Strathfield Local Planning Panel Meeting

Thursday, 7 February 2019

TO: Strathfield Local Planning Panel Meeting - 7 February 2019
REPORT: SLPP – Report No. 1
SUBJECT: DA2018/036/01 - 55 MYRNA ROAD, STRATHFIELD
LOT 46 DP 14613
DA NO. DA2018/036/01

Proposal: Section 8.2A review – Construction of a two (2) storey dwelling with basement level, in-ground swimming pool and boundary fence.

Figure 3: Survey with sewerage line traversing the rear of the site (highlighted in purple).

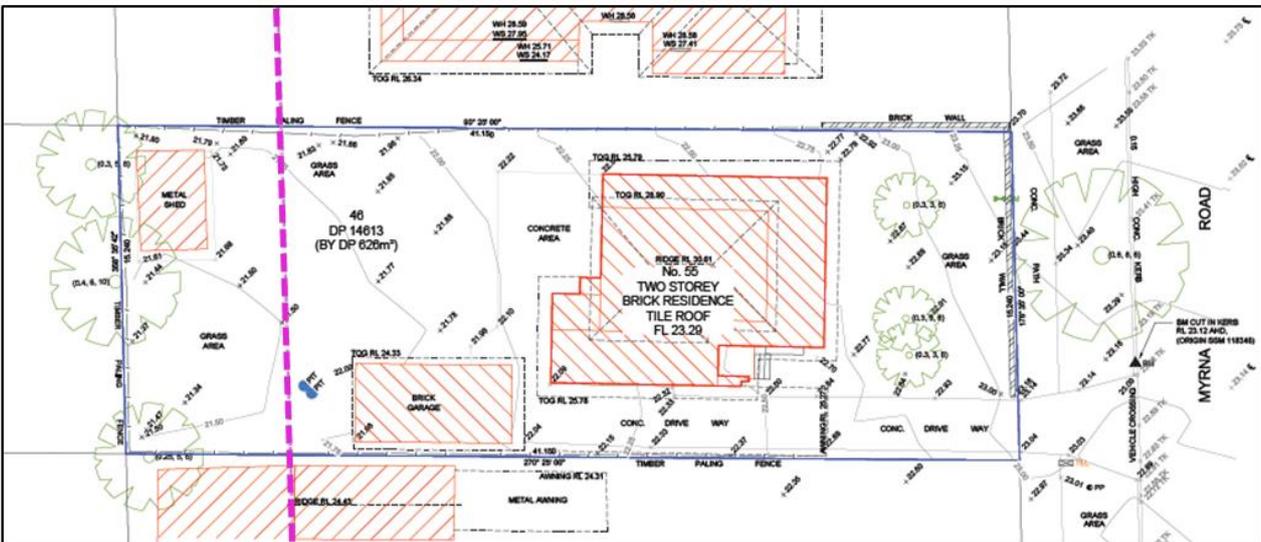
An underground sewerage line traverses the rear of the site (shown in Figure 3). The proposed dwelling has been appropriately designed with all structures clear of the pipe.

Figure 4: Section drawing of the proposed dwelling including 9.5m height limit line.

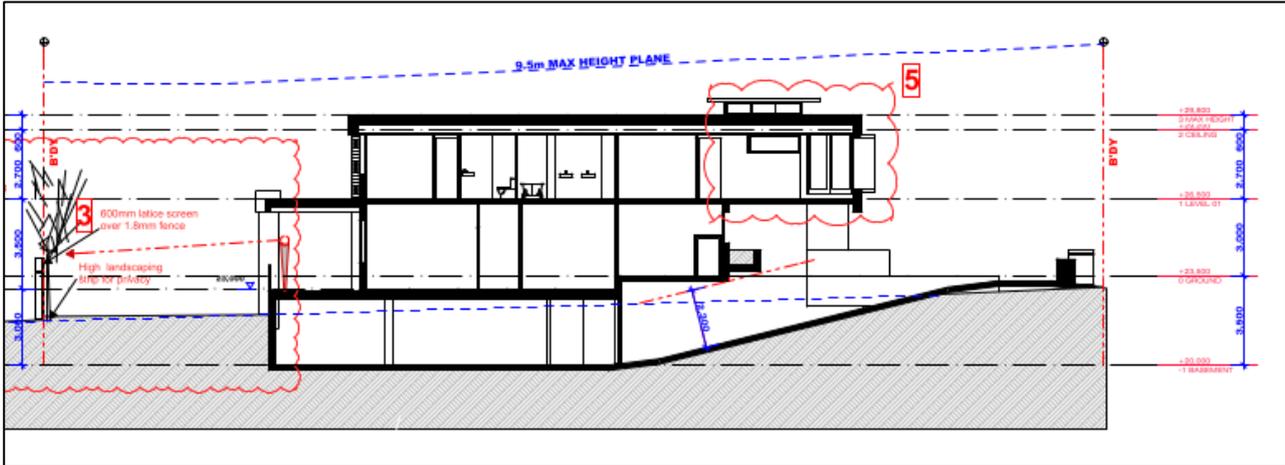
Comments: The proposed dwelling seeks a maximum building height of 7.95m which is well below the 9.5m maximum permitted under Clause 4.3 of the SLEP 2012 (refer to Figure 4). The overall building height is considered appropriate having regards to other two (2) storey dwellings in the surrounding streetscape.

Figure 5: Mid-winter shadow and sun's eye diagrams of the proposed dwelling showing its impacts on the adjoining property to the south.

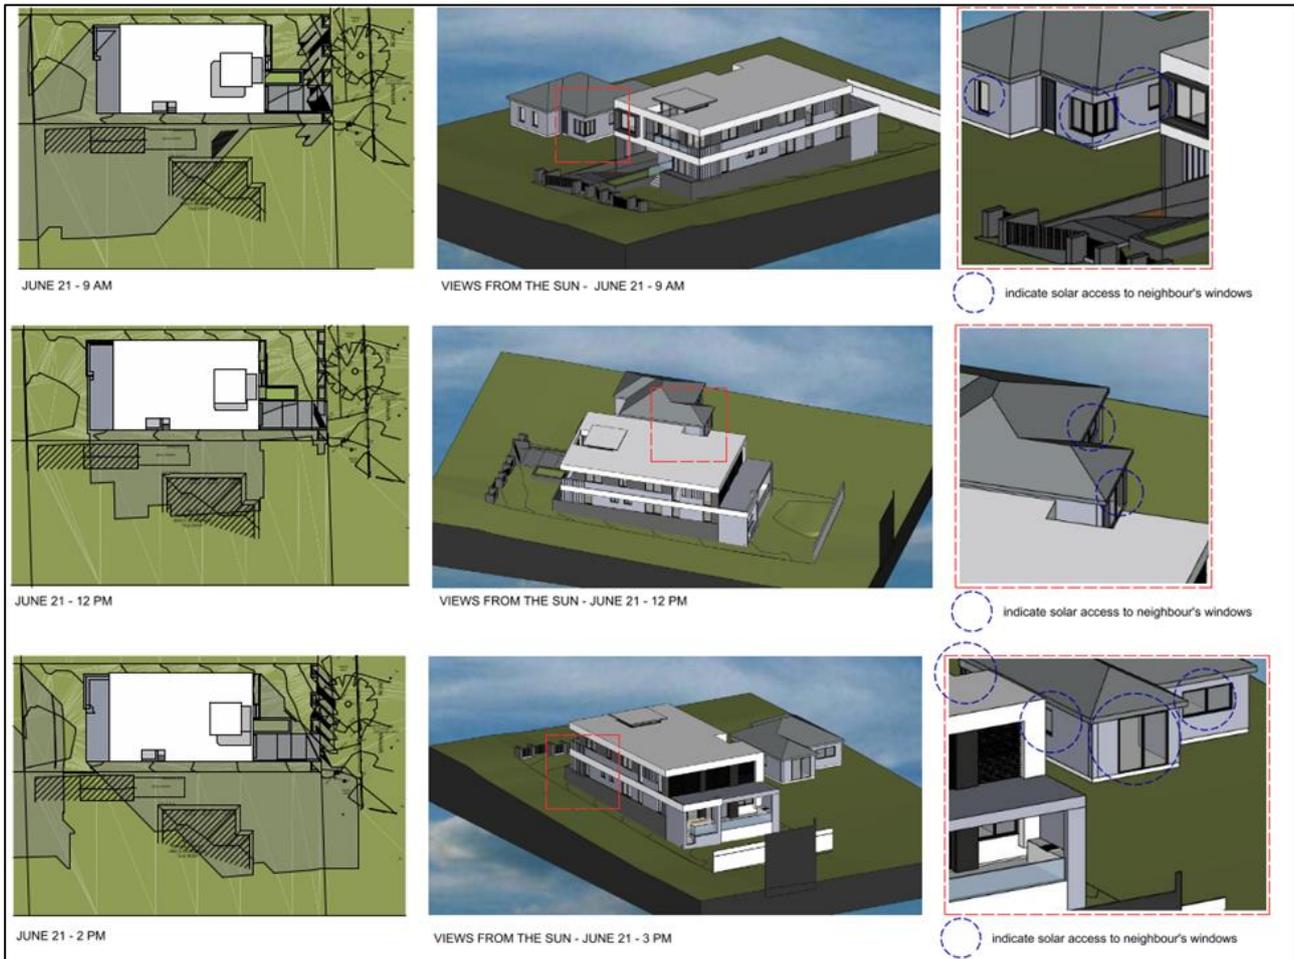
Comments: The subject site has an east-west orientation with the dwelling facing east, resulting in largely unavoidable overshadowing onto the adjoining single storey dwelling at No. 57 Myrna Road to the south of the site. As illustrated in Figure 5 at 9am in mid-winter the proposed development will cast a shadow to the south-west, shading the rear portion of the northern walls of the adjoining dwelling and its rear private open space. By noon the shadow has moved south, continuing to overshadow the northern wall of the adjacent dwelling and providing some solar access to the western facing windows and a reasonable portion of the private open space. At 3pm, the proposed dwelling will continue to cast a shadow on the northern wall of the adjoining dwelling at No. 57 Myrna Road, with the rear windows and private open space receiving solar access.

Figure 8: Basement plan overlaid with building footprint.

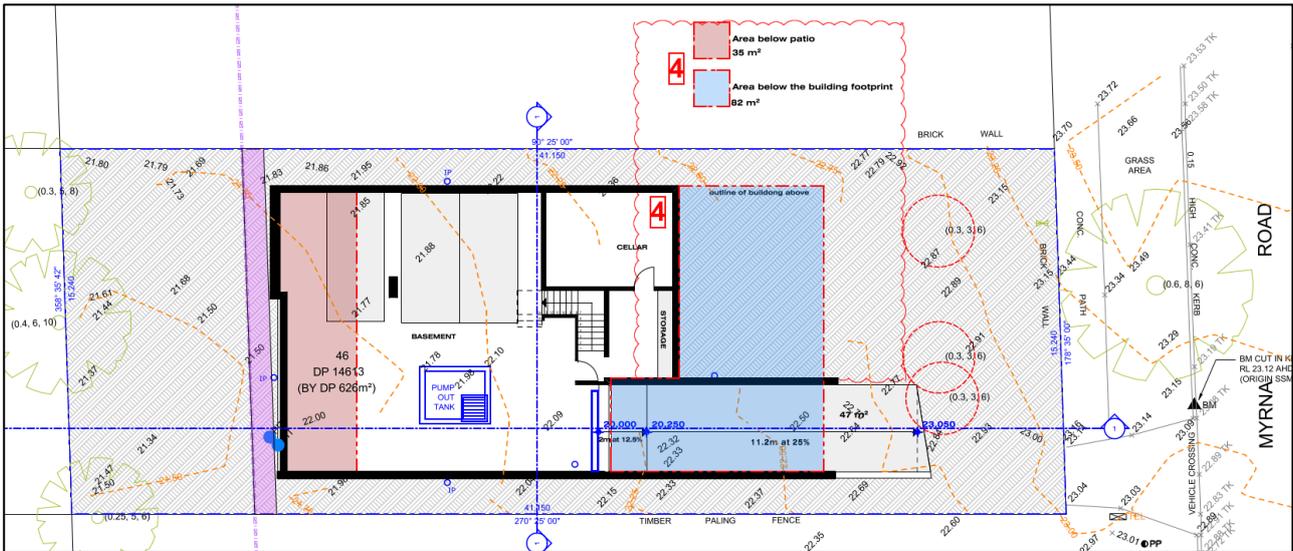
Contrary to Section 8.2.3 of the SCDP 2005, the basement is not contained within the building footprint of the dwelling as illustrated in the Figure below. The non-compliance can be partly attributed to the gradient and considerable length of the driveway ramp required to accommodate a crest to prevent flood waters entering the basement. Proportionally, the basement is less than the dwelling footprint and not excessive in size. Given the flood planning constraints of the site and their influence on the design of the basement in terms of necessitating a lengthened driveway, the variation to the basement footprint control is considered acceptable.
